Engine Wiring Harness Chafing – 200/225/250/275 Verado

Models Affected

Models Covered	Serial Number
200/225/250/275 Verado	1B390142 and Below
EU 200/225/250/275 Verado	0P468636 and Below

25711

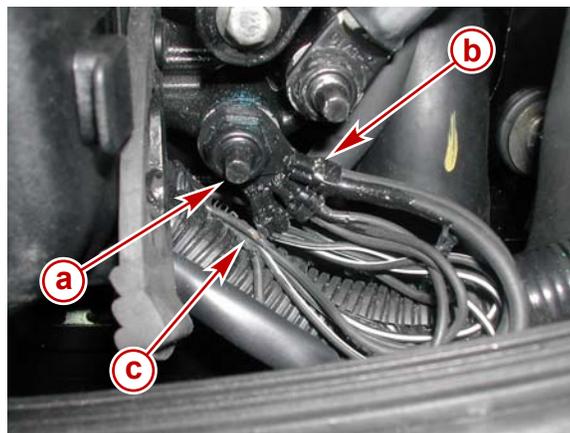
Mercury Marine has identified a potential engine wiring harness chafing issue located on the starboard side of the engine near the lower forward corner of the electrical box. As the ground wire ring terminals are secured with the grounding stud locknut, the terminals can fan out toward the engine wiring harness conduit. Wires protruding out of the conduit slit at this location can become chafed by the wire crimped portion of the ground wire ring terminal and be shorted to ground. Depending on the wires shorted, an engine system failure and/or an engine guardian fault may occur. Mercury Marine has changed the orientation of the described ground wire ring terminals and corrected this issue.

- a** - Ground stud
- b** - Crimped end of ring terminal
- c** - Chafed wire

25712

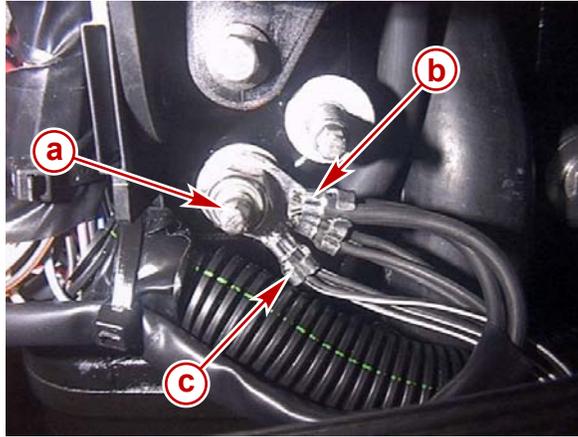
- a - Ground stud/locknut
- b - Ground lead ring terminals
- c - Ring terminal crimp too close to wiring harness

1. Remove the locknut securing the three ground lead ring terminals to the ground stud.

25713

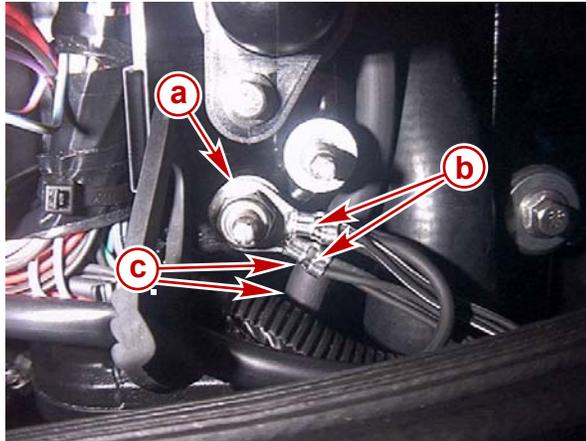
- a** - Heavy terminal - Crimp toward engine (positioned behind outer terminals)
- b** - Two remaining terminals - Crimp away from engine
- c** - Clearance between crimps and harness

2. Clean the neoprene protective coating from the ring terminals, ground stud, locknut, and the contact surface of the cylinder block mounting boss.
3. Reposition the ring terminals:
 - Heavy terminal should be installed first with the crimp toward the engine.
 - Two remaining terminals should be installed with the crimps facing away from the engine.
4. Stack and position the ring terminals to provide clearance from the engine wiring harness. Hold the ground wire terminals in this position and secure the connections with the locknut.

Description	Nm	lb. in.	lb. ft.
Locknut (M8)	17	150
